CORRIGENDUM 1

B.3 Calculation

B.3.1 Calculation algorithms of the impedance for a.c.

Figure B.3 – Percentage of internal resistance of the human body for the part of the body concerned

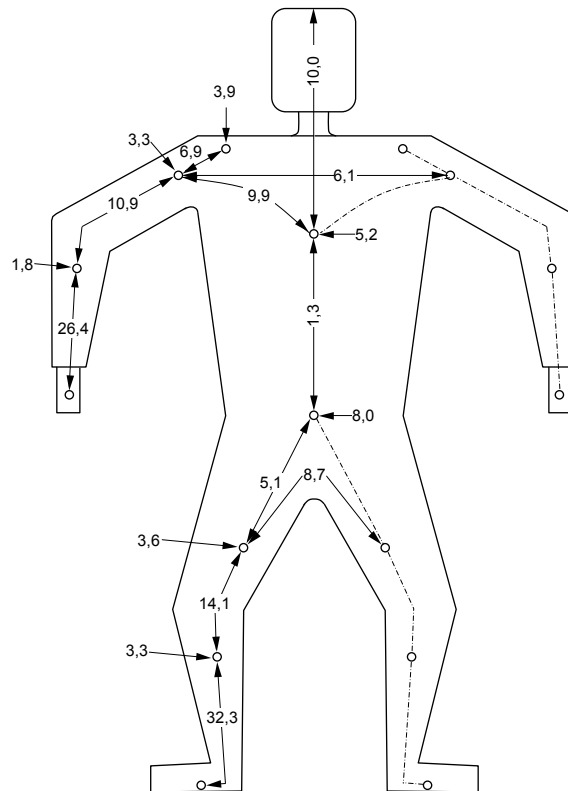
*Replace the existing Figure B.3 by the
following new figure:*

Replace the existing calculation in the first dash after Figure B.3 by the following:

Replace the calculation that appears in the penultimate paragraph before Formula (B.10) by the following:

Replace the existing Formula (B.10) by the following new formula:

$$26,4 \% + 10,9 \% + 6,1 \% + 10,9 \% + 26,4 \% = 80,7 \%$$

$$\frac{50,65 \%}{80,7 \%} = 0,628 \text{ times}$$

$$R_{ih-f} = R_{ih-h} \times 0,628 \quad (B.10)$$
